**KNOXVILLE HISTORIC ZONING COMMISSION
STAFF REPORT - CERTIFICATE OF APPROPRIATENESS APPLICATION**

PROPERTY ADDRESS: 123 W Jackson Ave 37917

FILE NO.: 12-F-15-HZ

Postponed from 12/17/2015 HZC meeting: Replace left storefront window with a single wood-framed glass door and a matching adjacent fixed glass panel (with wood panels below) to mimic the existing pair of central entry doors. Install a mullion in the center of the left storefront to accommodate interior wall and a faux mullion in the middle of the right storefront window to match. Dimensions of muntins, doors and fixed panels as noted on drawings. Install a new step at new door to match the existing step.

123 W. Jackson Avenue photo from Library of Congress

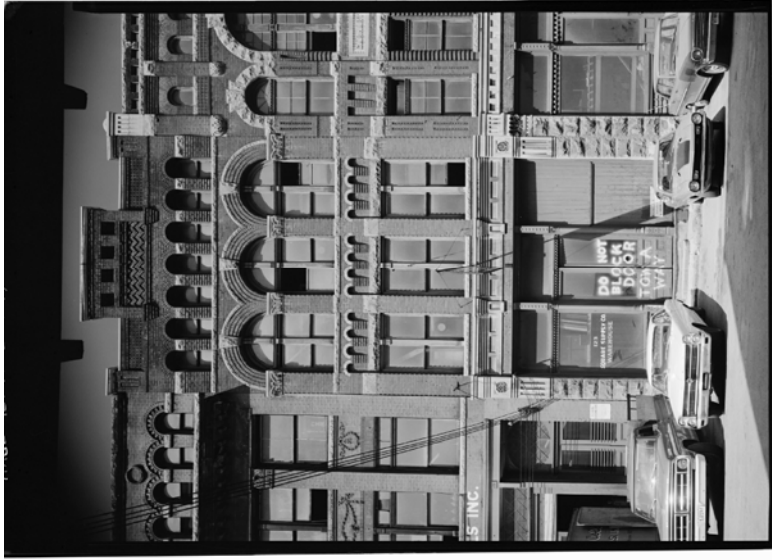
- 2) Documentary photos from the Library of Congress of 121, 123 and 120, 122 W. Jackson indicate that the original storefronts flanking double-leafed entry doors were filled with a large single pane of glass and were not originally divided by muntins.

- 3) The right (east) storefront section of 123 W. Jackson had been altered in years past (based on documentary photographs) by the removal of the transom and a horizontal division in the storefront window.

Front Elevation - Double Door Option
 127, 125, 123 West Jackson Avenue
 Knoxville, Tennessee

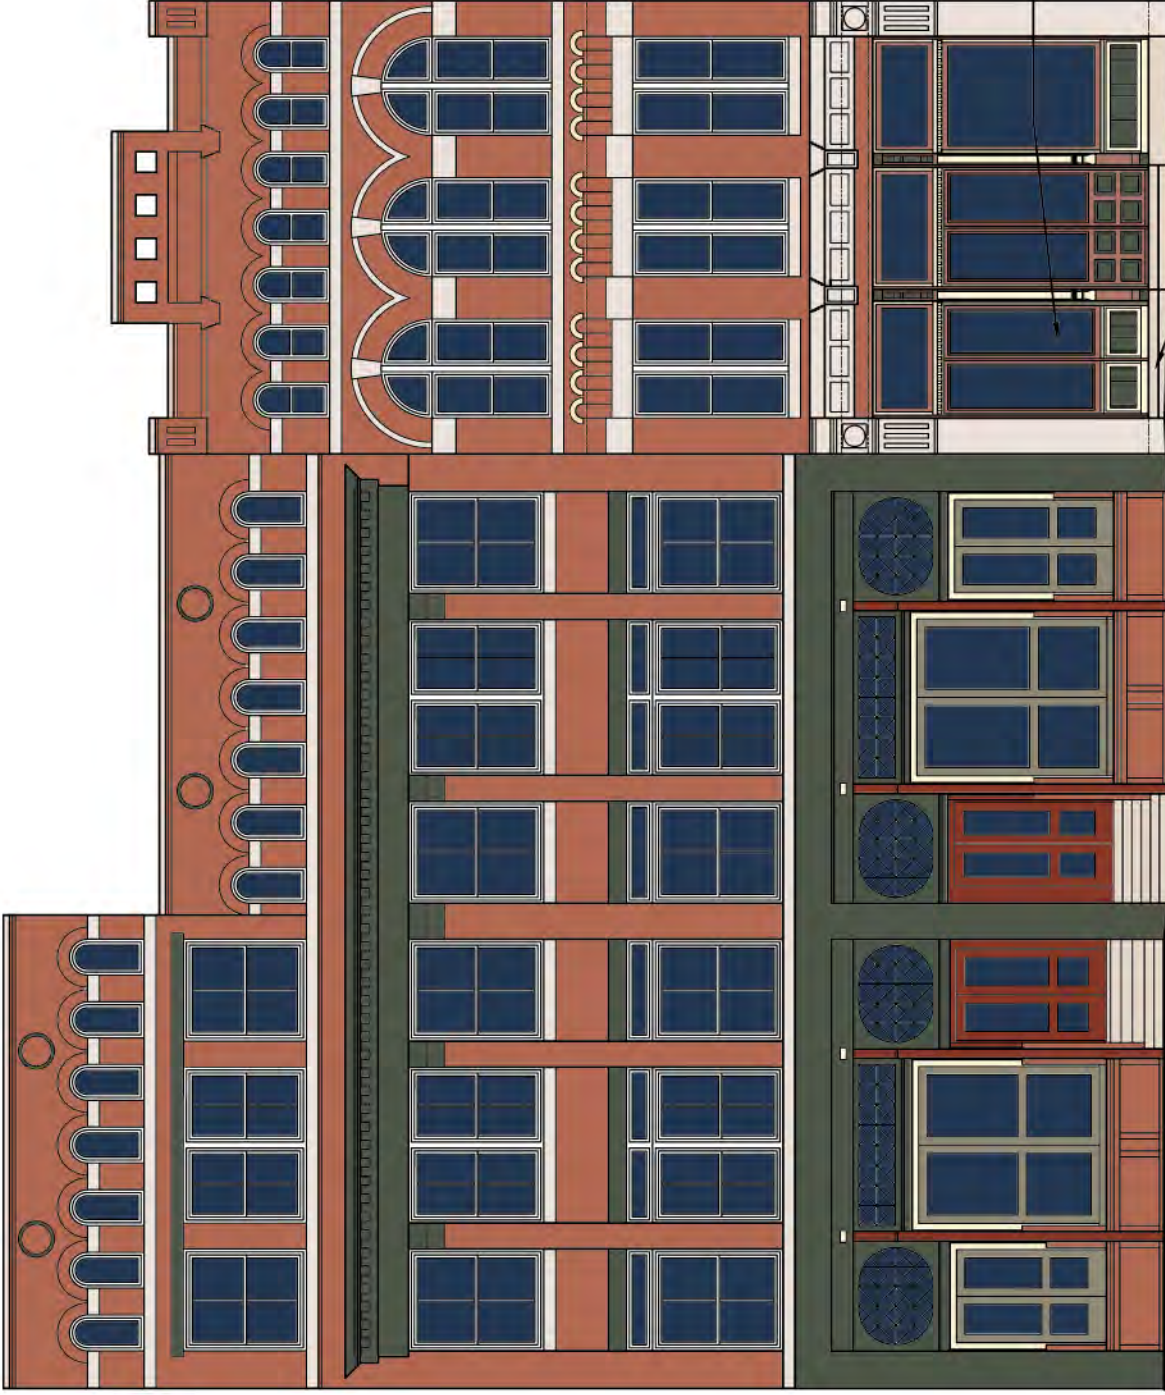
- 5) Replacing the west (left) storefront glass with a pair of double-leafed doors (to match the paired central doors) would eliminate the need for door framing in the middle of the window making a less pronounced central division of the storefront window.

- 7) If a pair of double doors were added to the left storefront section, the width of the door frames in the center of the section would be 9", which would match the width of the door frames in the existing central entry.

Approval of installing a double-leafed door since the framing between the two door leafs would create a less prominent vertical division than a single door and fixed panel. The solid vertical framing division would be the same width as that of the existing central double-leafed doors. Denial of dividing the original single-paned right storefront window with the installation of a center mullion since it would unnecessarily create a false sense of history.

Front Elevation - Single Door Option With Muntin

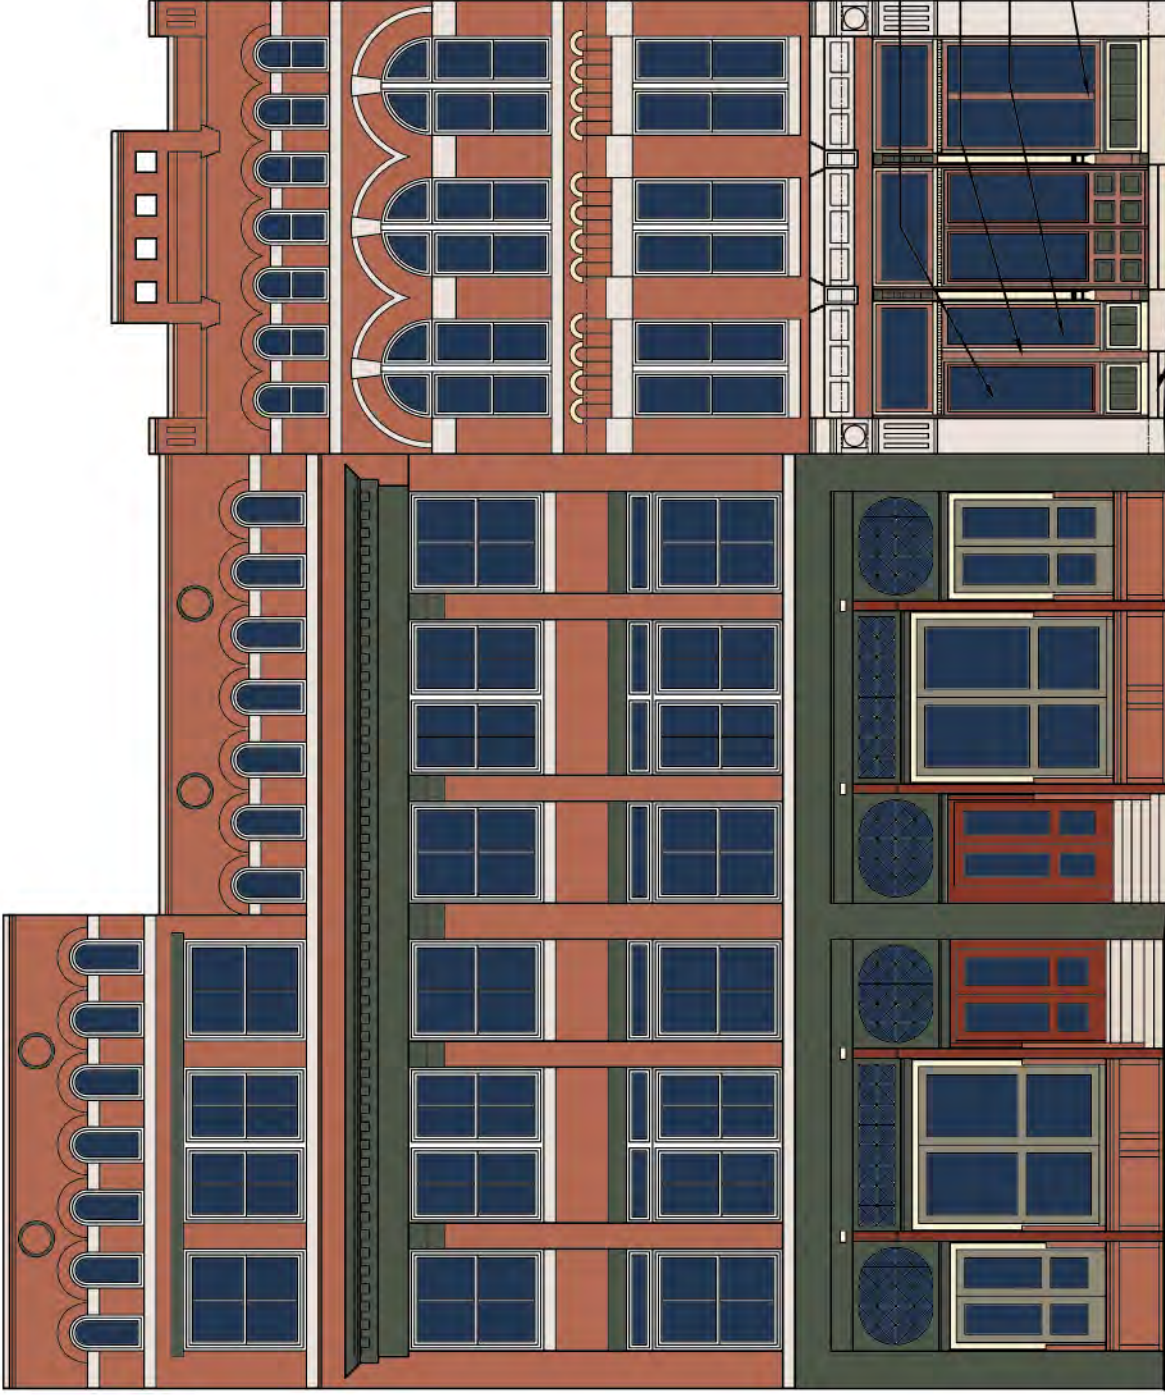
- 4) Replacing the west (left) storefront glass with a single door and adjacent fixed panel would require that approximately 15-inches worth of structure and door framing would divide the historically single-paned section into two.

- 6) The approximate widths of the proposed muntins and framing added to the center of the left storefront window would be 15", and the right storefront muntin, if added, would be 5". The width of the stantion between the center pair of doors is approximately 9". Therefore, the vertical dividing elements of the storefront glazing will not be the same widths.

- 8) A muntin applied to divide the storefront glass to the east (right) of the main entry to match a new one on the left and for the sake of establishing symmetry would portray a false sense of history.
